UNITED STATES PATENT AND TRADEMARK OFFICE

APPLICATION NO.	FILING DATE	FIRST NAMED INVENTOR	ATTORNEY DOCKET NO.	CONFIRMATION NO.
10/716,510	11/20/2003	Alan S. Reitz	P69265US0	5624

Office Action Summary

FIG. 8

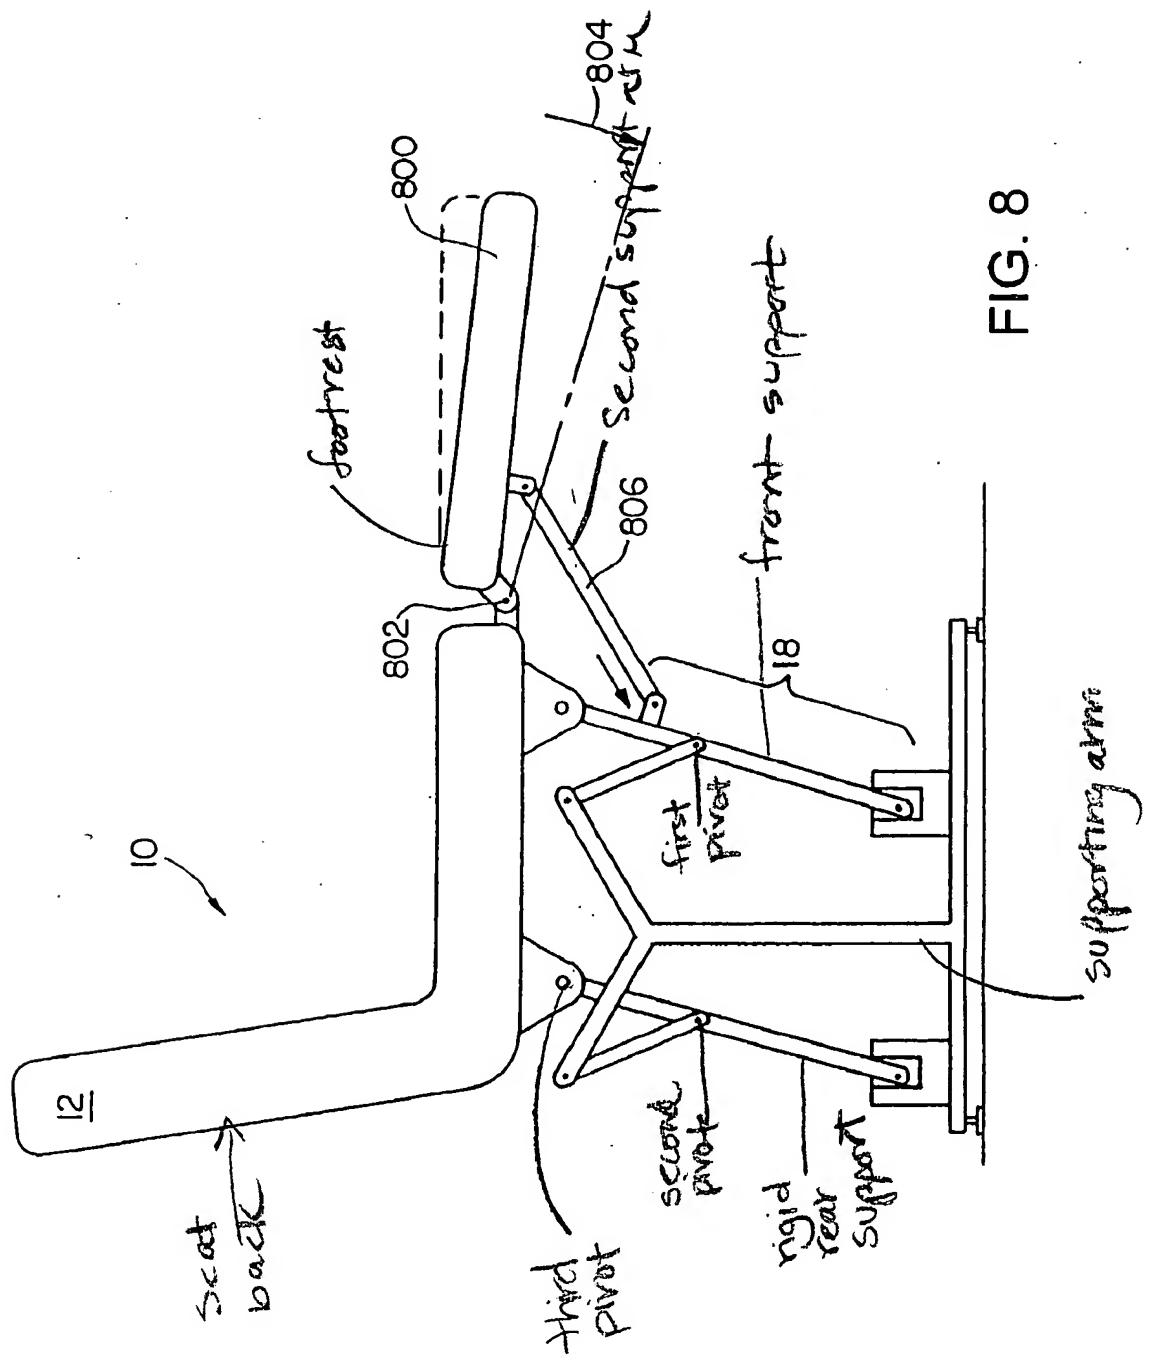
2. Claim 23 is rejected under 35 U.S.C. 103(a) as being unpatentable over Garland. Garland discloses exercise chair comprising an upstanding front support pivotal about a transverse axis at lower end thereof, upstanding rigid rear support, a supporting arm having seat supported therefrom, first pivot connecting a forward end of said arm to the upper end of said front pivotal support, a seat back connected to a rearward end of said arm by a second pivot, and a third pivot connecting the upper end of said rigid rear support and said seat back, said third pivot located at position spaced above said second pivot (see annotations on Figure 8). Regarding the language "to vary the force seat and seat back between upright and reclined positions when exerting a rearward force on said seat back and to move said arm and seat forwardly about the second pivot and to pivot upper end of said front support about the transverse axis lower end, with relaxation of said force enabling an occupant's weight on the seat an upright position return said seat and seat back to an upright position" has not been given patentable weight because the recitation is purely functional in nature and does not recite any structure. Garland discloses all of the limitations of the claimed invention except for the third pivot being adjustable. It would have been obvious to one having ordinary skill in

the art at the time the invention was made to modify Garland such that adjustability of an element provides greater range for the device. Adjustability, where desirable, is a modification that is within the skill of the art. In re Stevens, 212 F.2d 197, 101 USPQ 284 (CCPA 1954).
